project
Edenbrook Drive, Parkhurst

RRC Ref: D/37-2017_one lot into 18 Stages 7(A B & C)
Our Ref: 1096_Response to ROL Information Request

D/37-2017, ROL APPLICATION, 1 LOT INTO 18 LOTS Lot 253 & LOT 254 SP241210 – EDENBROOK STAGE 7 (A, B & C)

We acknowledge on behalf of the Applicant receipt of Council's letter dated 4 April 2017 wherein further information is requested. The Applicant has approved the attached Rev 3 set of ROL Drawings (some minor allotment dimension changes) and the following response:

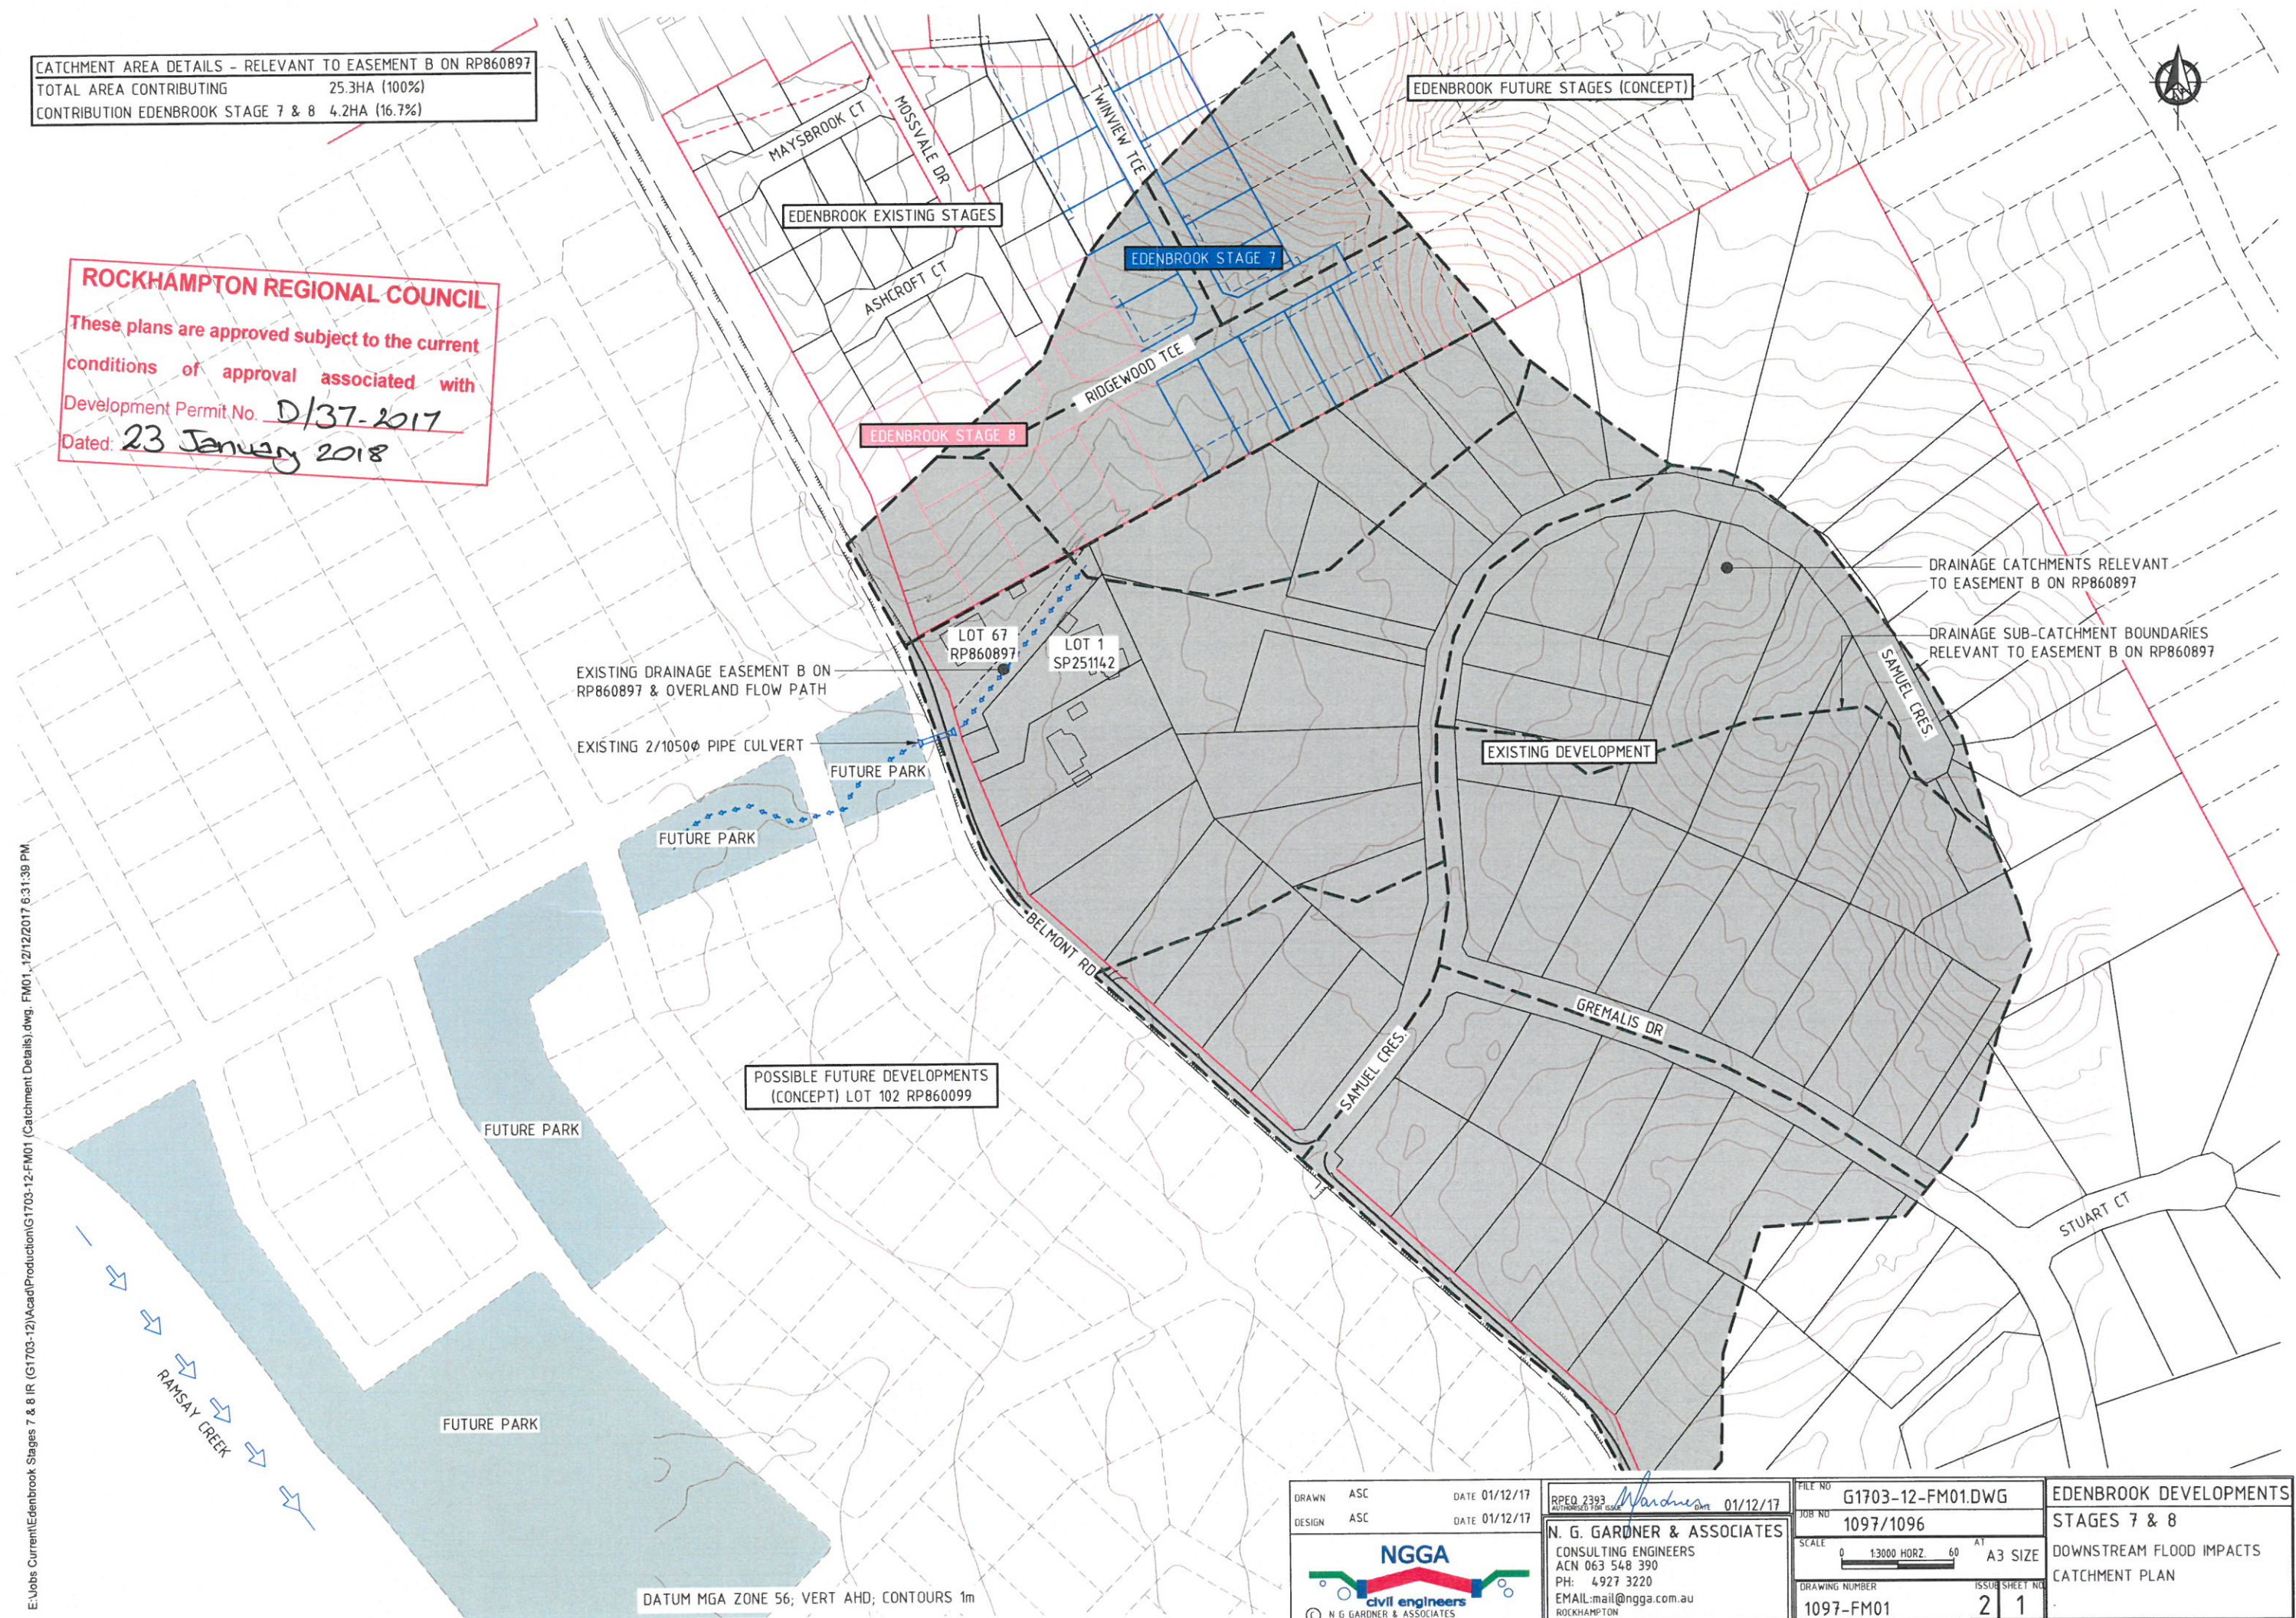
Supporting pre / post development calculations and flow path cross sections demonstrating the appropriateness of the proposed drainage arrangement, as well as any required agreement from the affected downstream property owners, must be submitted to Council prior to any approvals being granted. Please amend the application accordingly to address these matters.

Drawing 1097-FM01 - Catchment Plan including the approved layout west of Belmont Rd.

The overall catchment with sub-catchments is shown on Drawing No 1097-FM01.

The relevant portion of the catchment within Edenbrook is 4.2 hectares and this represents 16.7% or one sixth (1/6) of this overall catchment of 25.3 hectares.

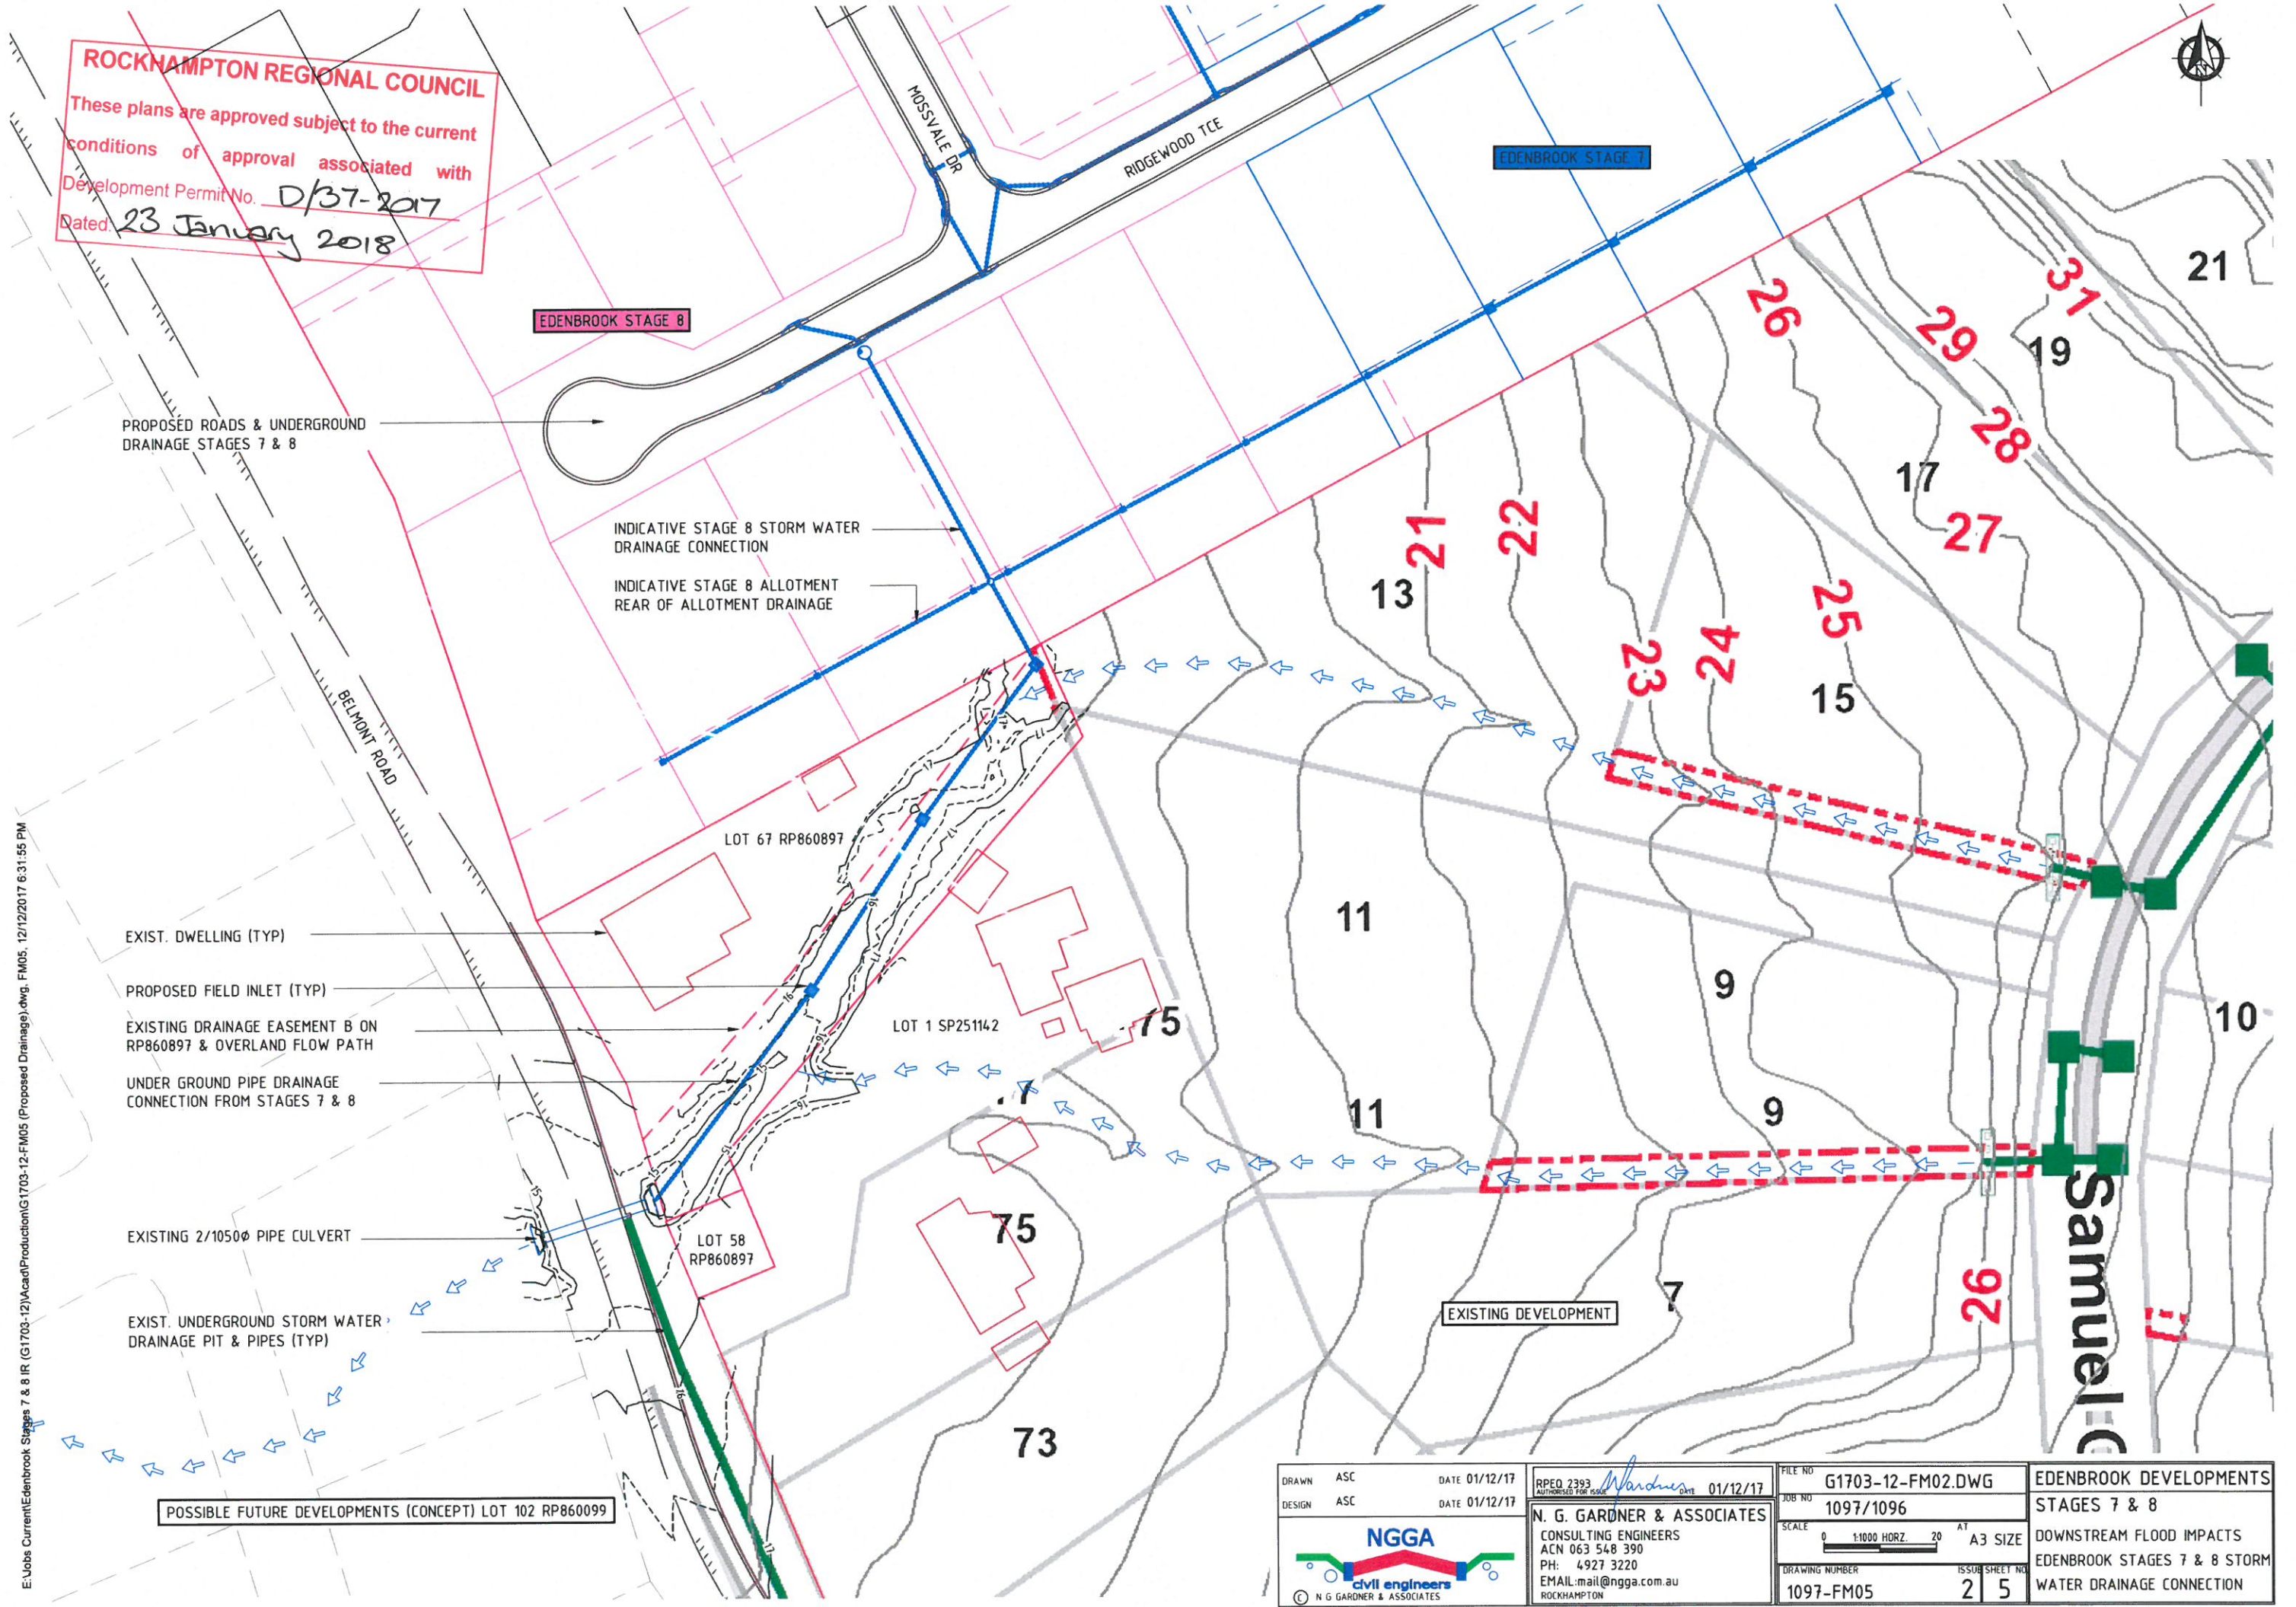
1.1 A portion of the subject development site drains to the south through an existing easement adjacent to Lot 67 on RP860897 (97 Belmont Road, Parkhurst). The applicant has stated that they accept that Council will impose a condition to reach an agreement with the neighbouring property owners to adjust this easement to accommodate the stormwater flows from the subject development; however it is appropriate that these negotiations occur as part of the subject application. The submitted documentation does not propose any mitigation measures to limit the peak flows from the site to that of the pre-development scenario and Council is concerned that the existing downstream drainage infrastructure may not be sufficiently sized to accommodate the additional runoff from both the subject development, and the future stages that will also be directed through this easement.

Drawing 1097-FM05 - Preliminary design of proposed pipe infrastructure in Easement B

If essential for Stage 7B and 7C to ensure that the owners of Lot 67 have no concern about perceived changes in catchment conditions or the effect of any outfall of drainage above, through or into Easement B in their property, the developer (the Applicant) is prepared to pipe the Q5 flow (as a minimum) through Easement B and fully remediate the affected land within the easement. Attached Drawing No 1097-FM05 shows an indicative layout.
